# Recall Bulletin

**SUBJECT:** "Service Active Handling System" Message in Driver Information Center

**MODELS:** 2005-2006 Chevrolet Corvette  
 Equipped with Tilt and Telescoping Steering Column (N37)

2030089

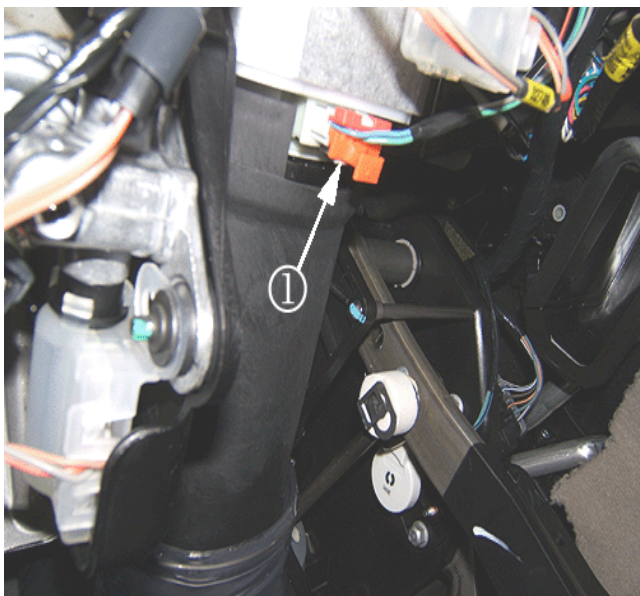
1. Remove the driver's side closeout (insulator) panel.
2. Locate the Steering Wheel Position Sensor (SWPS) connector that connects to the steering angle sensor, located on the lower center of the steering column.

**Note:** Determine if the (SWPS) connector has a clip installed into the connector, or if tape and a band tie was used to prevent movement of the terminals.

- If the SWPS connector has the clip or tape and band tie repair, install the driver's side closeout (insulator) panel. No further action is required.
- If the SWPS connector does NOT have the clip or tape and band tie repair, proceed to Step 3.

3. Install the new clip into the connector. This clip will act as a terminal positive assurance (TPA) and prevent any movement of the terminals.
